## POCONO TOWNSHIP PLANNING COMMISSION

### AGENDA

**SUBJECT: SUMMIT ROAD SOLAR ARRAY SKETCH PLAN REVIEW NO. 1  
POCONO TOWNSHIP, MONROE COUNTY, PENNSYLVANIA  
POCONO TOWNSHIP LDP NO. 1439, T&M PROJECT NO. POCO-R1090**

**SUBJECT: SIMPSON MINOR SUBDIVISION 519-520 POST HILL ROAD  
FINAL MINOR SUBDIVISION PLAN REVIEW NO. 3  
POCONO TOWNSHIP, MONROE COUNTY, PENNSYLVANIA  
POCONO TOWNSHIP LDP NO. 1426, T&M PROJECT NO. POCO-R0750**

SHEET TITLE: **CONCEPT PLAN**  
 SHEET NUMBER: **C-001**

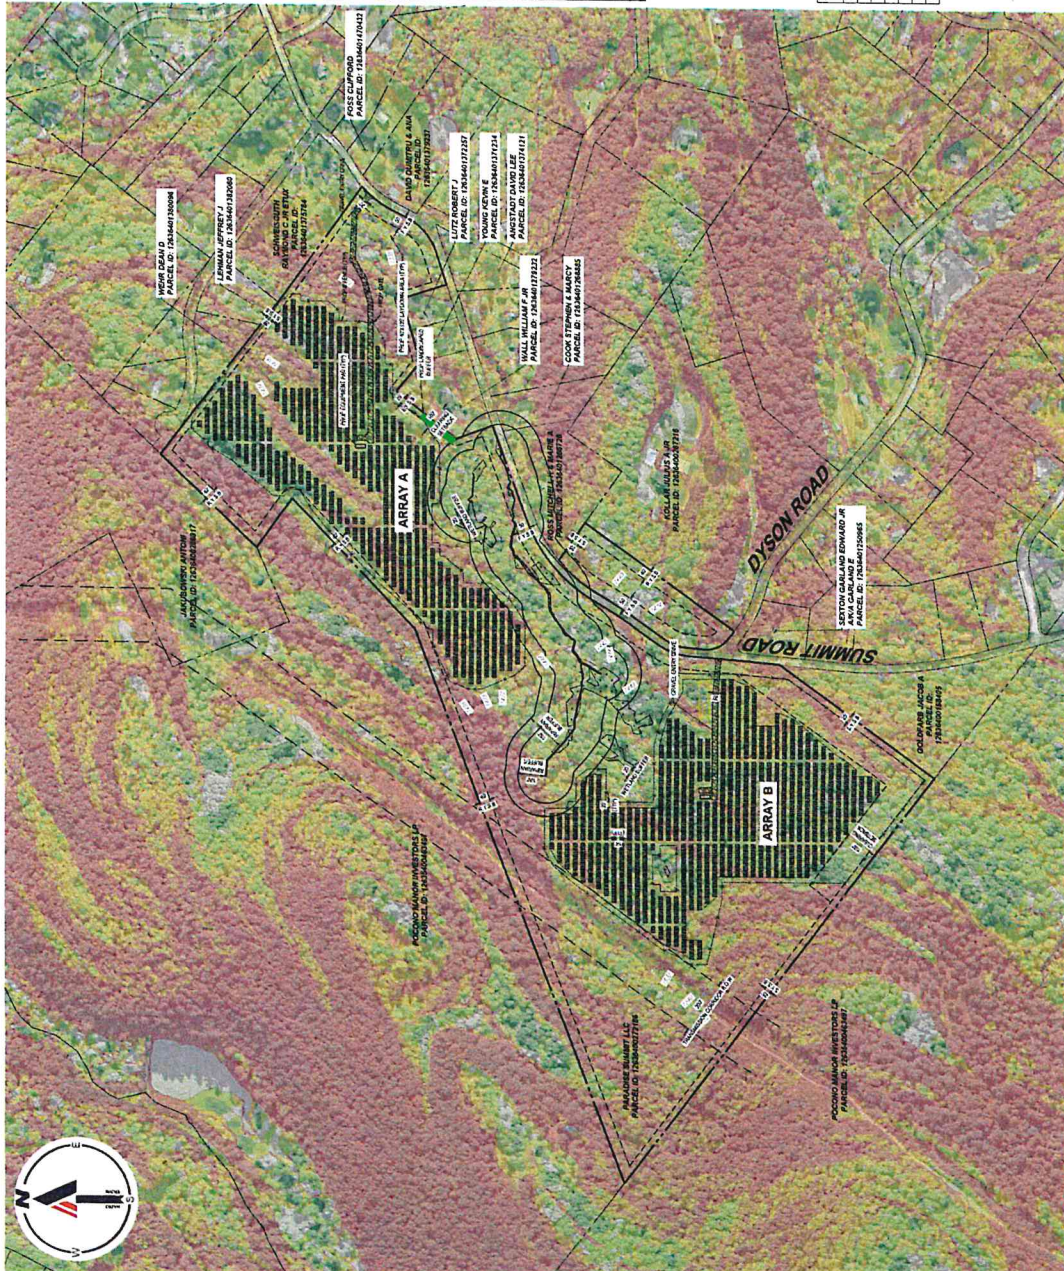
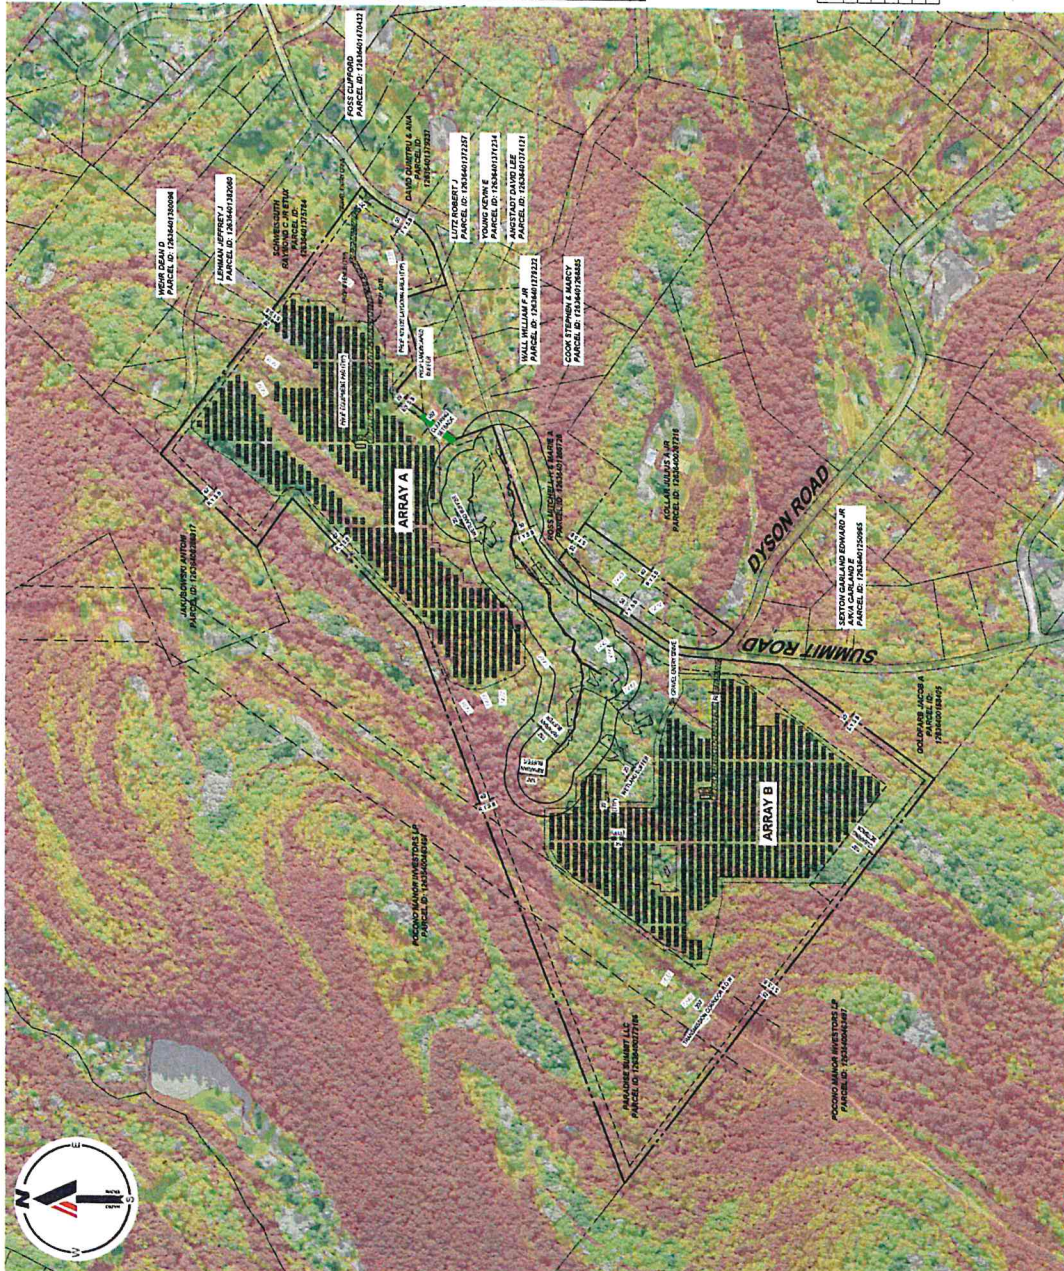
2. In accordance with Section 470-17.C.(1) and Schedule A, the maximum impervious area is 80%. *The proposed impervious coverage shall be provided on the Land Development Plan. The coverage shall include all gravel areas, racking support poles, substations, equipment pads, etc.*

4. In accordance with Section 470-57.E, Essential Services, Screen Planting, "the required equipment shall be screened in accordance with the requirements of this chapter and of Chapter 390, Subdivision and Land Development". *The required landscaping shall be provided on the Land Development Plan.*

7. In accordance with Section 390-43.A.(6)(e)[2][a], "no more than 35% of the original ground cover within any designated steep slope area on the property may be disturbed by grading, filling or other means. At least 65% of the original ground cover must remain undisturbed during the establishment, alteration or maintenance the property." *It appears steep slopes will be disturbed with the development. The Land Development Plan shall include a chart providing the existing area, the disturbed area, and the protected area of the existing steep slope.*

8. In accordance with Section 390-48.H.(1), "wherever there exists a dedicated or platted portion of a road or alley along a boundary of the tract being subdivided or developed the remainder of said road or alley shall be platted to the width required by this chapter based on the classification of the road within the proposed development". *Summit Road is considered a Local Road and shall meet the standards of a Local Road listed in Table 390-48-1. The Land Development Plan shall include the existing and proposed right-of-way and cartway widths of Summit Road.*

9. In accordance with Sections 390-48.T.(11) and 390-48.T.(13)(c), all access driveways shall be paved in their entirety in accordance with design specifications of § 390-59.D. *The Sketch Plan shows two (2) gravel driveways. The Land Development Plan shall include paved driveways as required by this Section.*

*The Sketch Plan proposes a 20-foot wide gravel driveway. The driveway width shall be revised as required by Section 390-48.T.(13)(b) of the Subdivision and Land Development Ordinance.*

11. In accordance with Section 390-48.AA., "sidewalk and road crosswalks may be required where necessary to provide proper pedestrian circulation or to provide access to community facilities and common areas. Sidewalks, where required or provided, shall be located within the road right-of-way immediately adjacent to the curbs, except as may be approved by the Township to accommodate road trees or other landscaping. Sidewalks and road crosswalks shall be constructed in accord with the most current PennDOT RC67M standard and Americans with Disabilities Act standards." *The Applicant shall discuss the need for sidewalk along Summit Road with the Township.*

12. In accordance with Section 390-50.B., a stormwater drainage and management plan shall be required for all major subdivisions and all land developments, and all subdivisions and land developments shall comply with Chapter 365, Stormwater Management. *Stormwater management in accordance with these requirements shall be addressed on future Land Development Plans.*

14. In accordance with Section 390-55., a landscape plan meeting the requirements of this section shall be prepared for all land developments and major subdivisions; and no land development or major subdivision shall be finally approved until all landscaping has been installed or guaranteed in accord with this chapter.” *A Landscape Plan is required for any future Land Development Plan submission. It is noted that a landscape buffer is shown along the shared property line with Parcel ID 12636401279232. A buffer along all areas between the solar arrays and existing residential properties shall be provided as required.*

# STREAM AND WETLAND BUFFERS SK-3

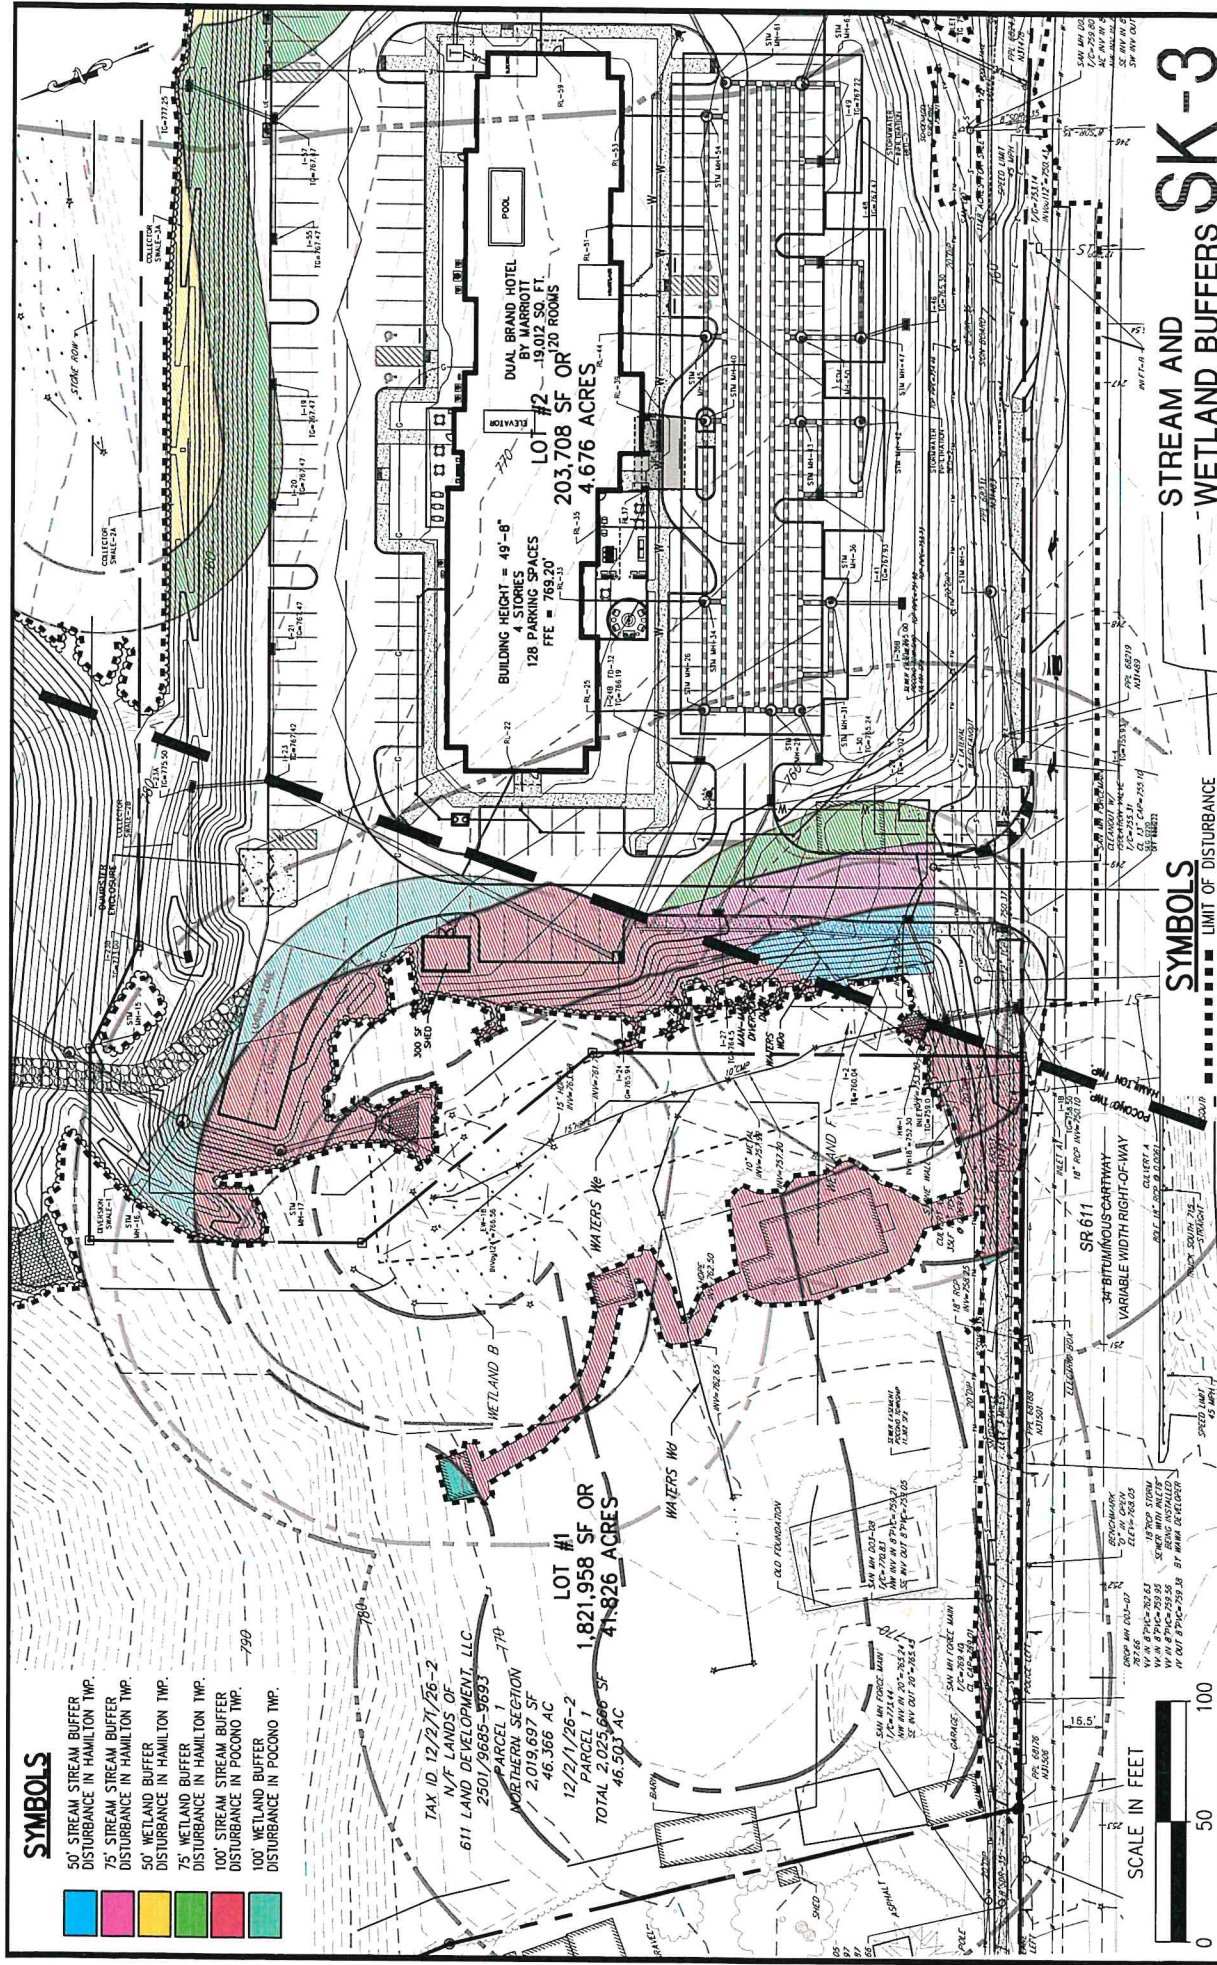
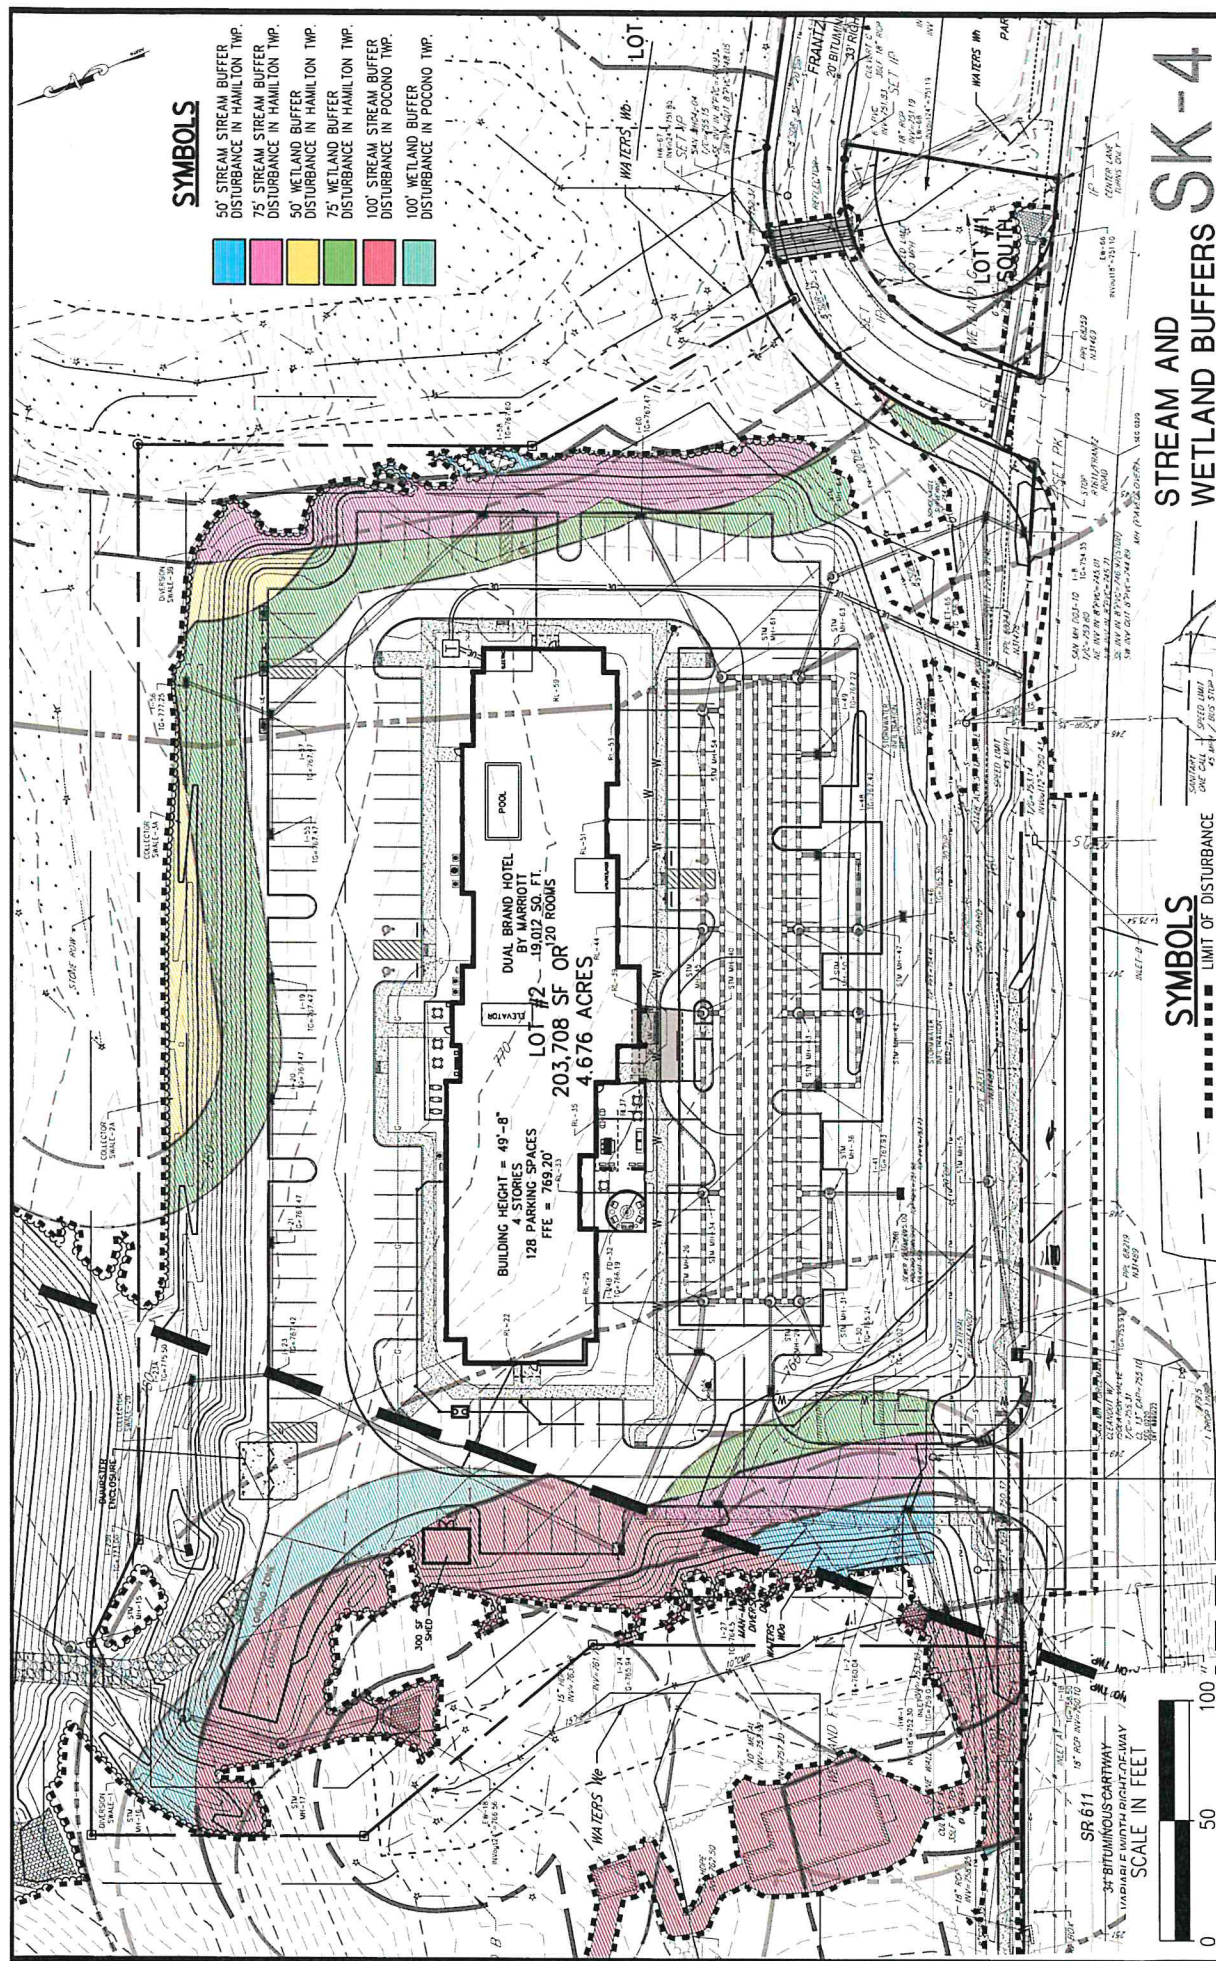
No wetlands are proposed to be disturbed on either Lot #1 or Lot #2. The volume of runoff to the wetlands will remain similar to existing conditional. The rate of runoff to the existing wetland adjacent to the water courses D & E was reduced to account for the limited capacity of existing culvert A.

As indicated on the plans, the total Preservation Areas, 50' wide stream easements, and slope easements within Hamilton, Pocono, and Stroud Township for Lots #1 and #2 are 858,934 SF or 19.718 acres. This represents 42.4% of the overall parcel, which excludes the disturbance of any wetland buffers.
